SERVICE BULLETIN**SB21-03**

TECHNICAL PORTIONS
FAA APPROVED**SUBJECT:** Potential Failure of Oil Temperature Control
Valve Part No. 657496**PURPOSE:** Notify customers of nonconformity in Part No. 657496 Oil Temperature
Control Valve manufactured in Q4 (fourth quarter) of 2020.**COMPLIANCE:** During the next scheduled oil change, or before next flight if experiencing oil
temperature indications near or greater than the specified operating limits.**MODELS****AFFECTED:** Continental Aerospace Technologies new and rebuilt engine model specifications
(I0550N, TSI0550C, TSI0550K, TSI0550N, TSI0F550K) using Oil Temperature
Control Valve (Vernatherm) Part No. 657496.**I. GENERAL INFORMATION**

**Figure 1. Oil Temperature Control Valve****III. AFFECTED ENGINE SERIAL NUMBERS**

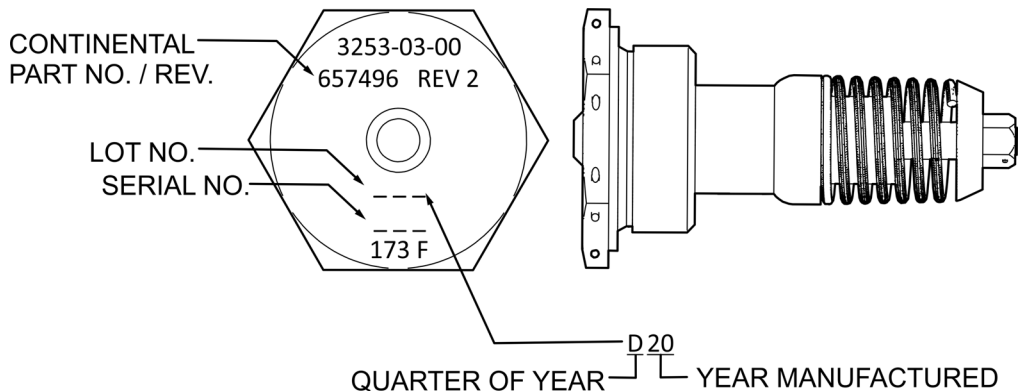
The lot number is etched on the cap of the assembly below the part number in the location shown in Figure 1. Remove and replace affected Part No. 657496, Vernatherm Assembly marked with lot number **D20** (2020Q4) with a serviceable unit.

Remove and replace the Oil Temperature Control Valve (Vernatherm) on affected engines according to the engine instructions for continued airworthiness. If oil temperature exceeds 240°F for more than 30 seconds, perform an oil change according to instructions in M-0, Standard Practice Maintenance Manual.
